MEMORANDUM

Date: September 25, 2019
To: Jim Edgmond, PE, City Engineer
Brian Stineman, Public Works Director
From: Jim Harbaugh, PLA
Principal Landscape Architect
Subject: Mississippi Drive
City of Muscatine
Project No.: A13.110401

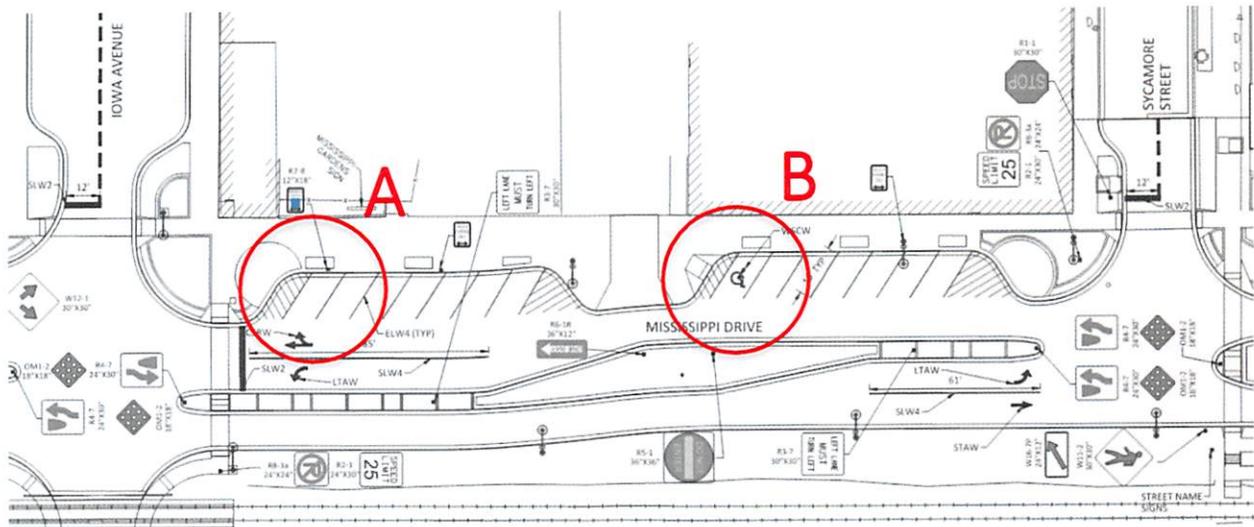
Although the aforementioned parking stalls are in compliance, to provide some further clarification on this block there are a few things that can be done:

- Option 1: Remove the handicap parking stall sign at the stall closest to the intersection of Iowa Avenue and Mississippi Drive (noted as stall A below). The handicap stall quantities exceed the minimum requirements for this block. Verify that the other parking stall in this block (stall B below) is signed and striped for van accessibility.
- Option 2: Add additional striping upstream of the parking stall at the corner of Iowa Avenue and Mississippi Drive and provide an additional curb ramp connecting this to the sidewalk along Mississippi Drive.
